Re: **SCI-823-6.81, Portsmouth Bypass Project, PID 19415**  
**Addendum to Report: Shumway Hollow Road (TR 234) Interchange**  
Embankment Stability, Time-Rate of Consolidation, Soil Cut Slope Stability  
DLZ Job No.: 0121-3070.03, Document No. 107

DLZ has reviewed ODOT-Office of Geotechnical Engineering's (OGE's) Stage I review comments (dated January 31, 2007) for Phase 1 of the SCI-823 project. In compliance with the review comments, DLZ has modified the slope stability analyses and time-rate of consolidation calculations for the Shumway Hollow Road (TR 234) interchange embankments. This document also elaborates on our previous recommendations for soil cut slopes and includes the output of the associated stability analyses.

Mainline Embankment-Undrained Analysis-Stage 1 Undrained  
SCI-823, Shumway Interchange, Stability Analysis  
Analysis Method: bishop simplified  
Undrained analysis using initial undrained shear strengths

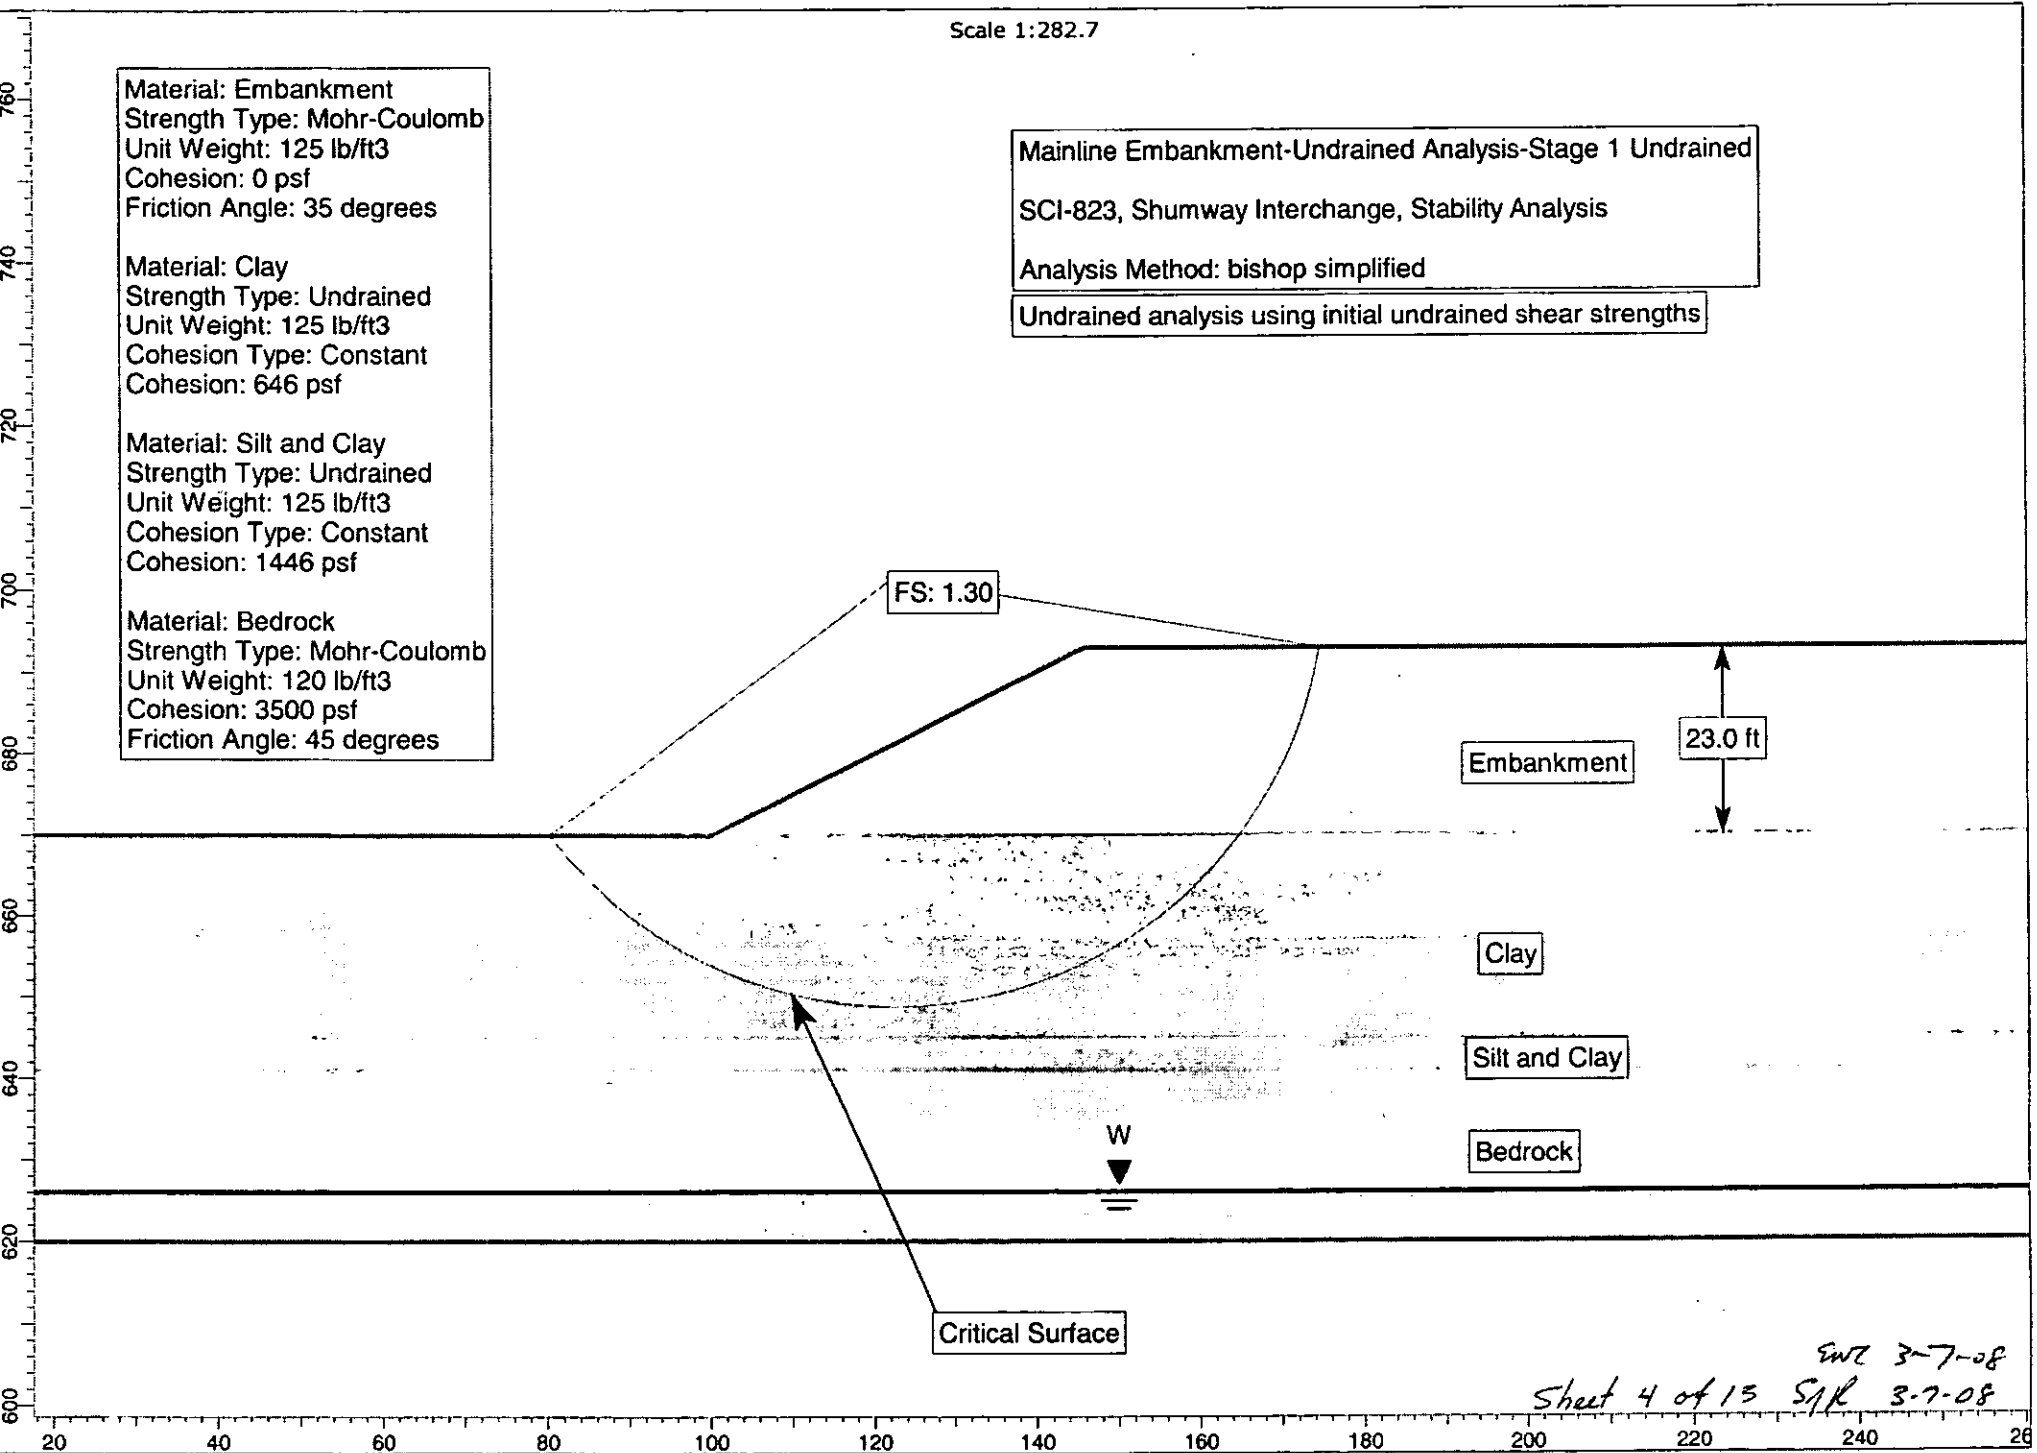
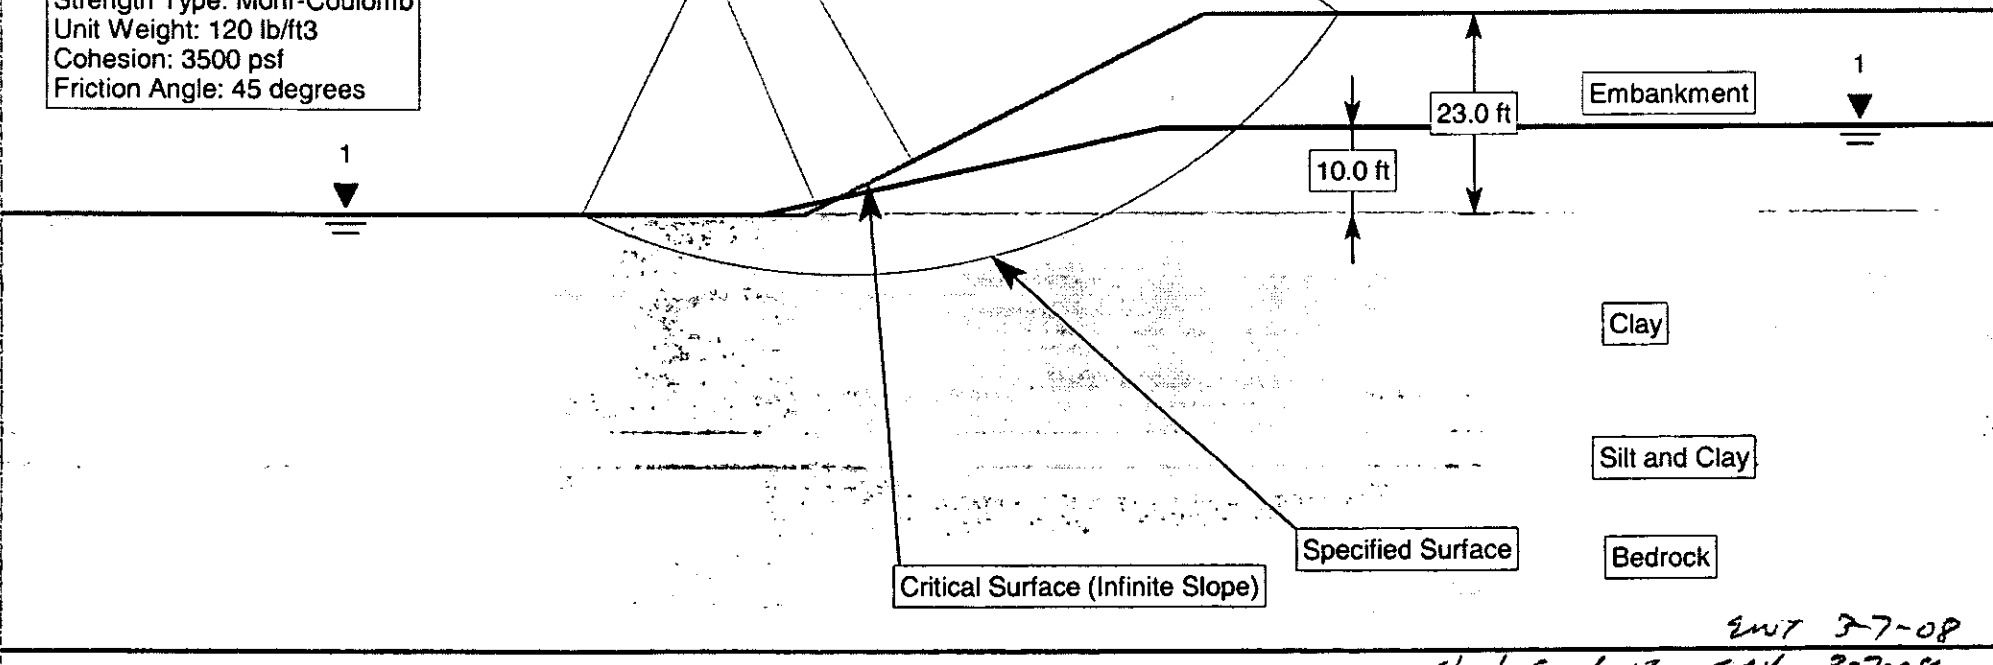
Due to the low in-situ undrained shear strength, construction of the interchange embankments using staged construction was investigated. Analyses indicate that the interchange embankments could be built in two stages. The first embankment stage may be constructed to a maximum height of 23 feet while maintaining the minimum required factor of safety of 1.30. After construction of the stage 1 embankment, a waiting period will be required prior to placing any additional fill. The waiting period is necessary to allow the foundation soil to consolidate under the influence of the stage 1 embankment load. Analyses indicate that at least ninety percent ( $U=90\%$ ) of the excess pore pressures should be allowed to dissipate prior to adding subsequent stages. In addition to the waiting period, the maximum pore water pressure head during the stage 1 embankment construction should not be greater than 10 feet above the existing ground surface. If the pore pressure rises above this level, the placement of fill should halt immediately to allow the level of the pore pressure to dissipate. The placement of fill may resume after

Mainline Embankment-Undrained Analysis-Stage 2 Undrained  
SCI-823, Shumway Interchange, Stability Analysis  
Analysis Method: bishop simplified

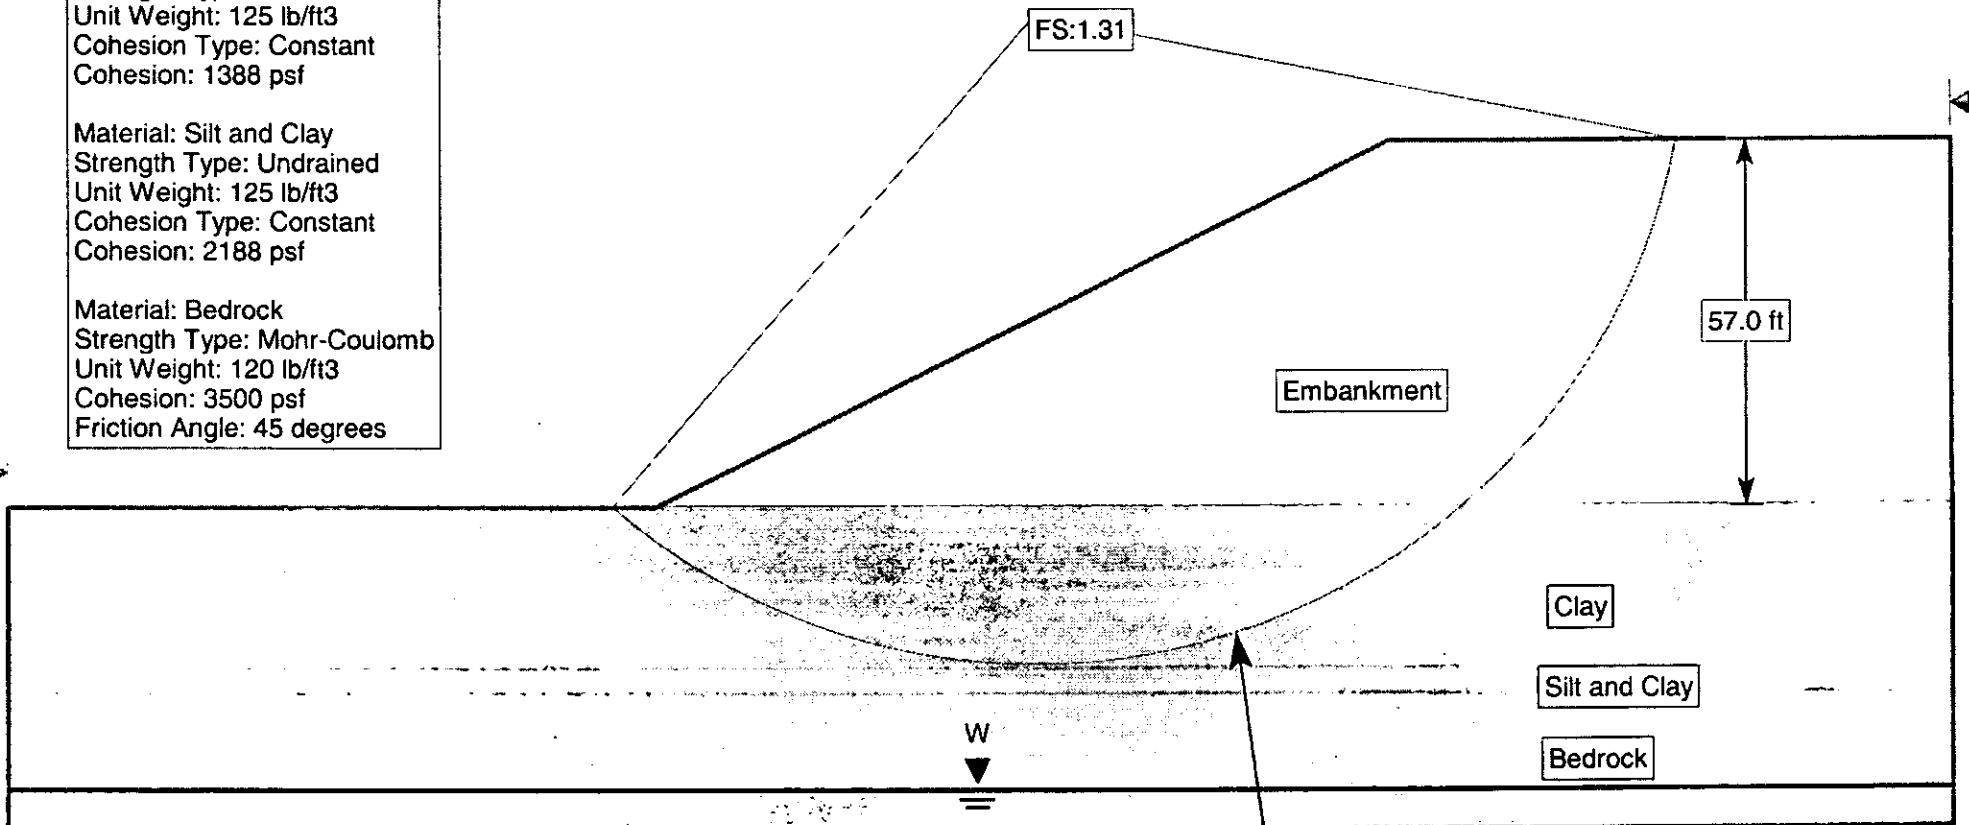
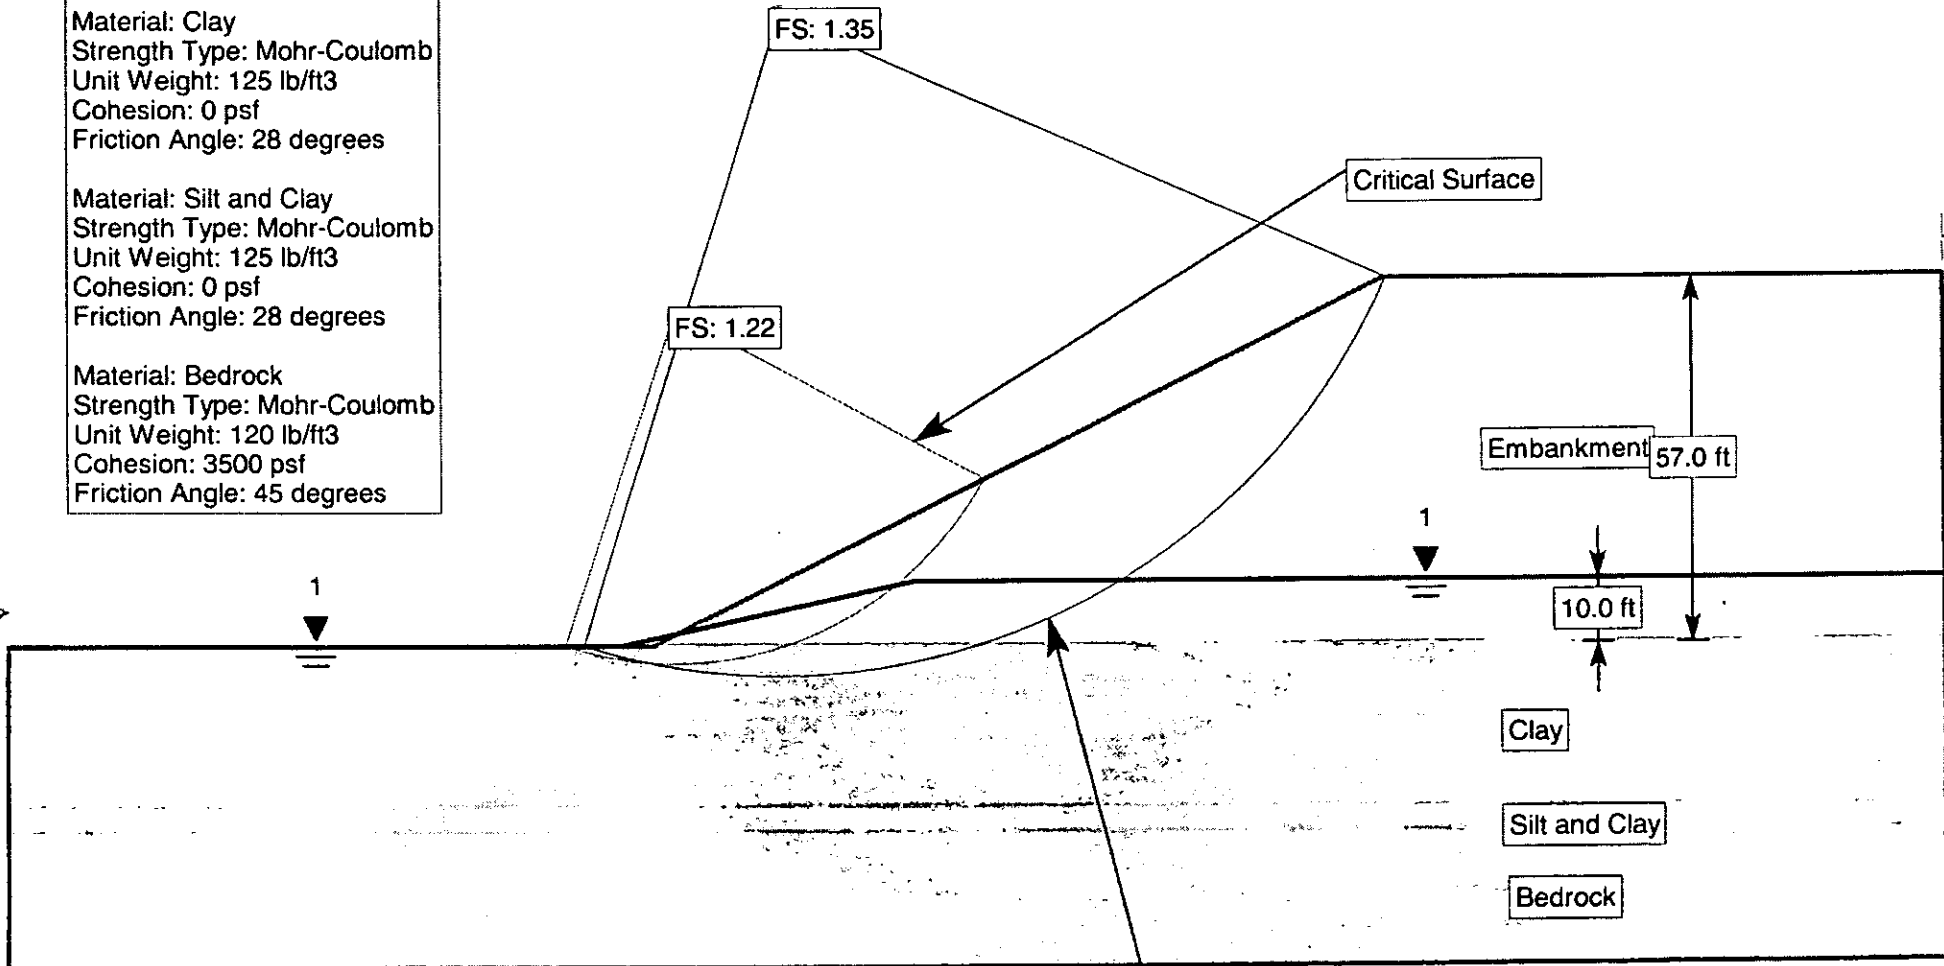
After the consolidation period (U=90%), fill operations for the stage 2 embankment may commence. The stage 2 embankment may be constructed up to the proposed grade level (57 ft). During construction of the stage 2 embankment, the maximum pore water pressure head should not be greater than 10 feet above the existing ground surface. If the pore pressure rises above this level, the placement of fill should halt immediately to allow the level of the pore pressure to dissipate. The placement of fill may resume after the excess pore pressure has dissipated to a level no greater than 10 feet above the existing ground surface. A summary of the analyses, as well as the graphic results of stability analyses are attached.
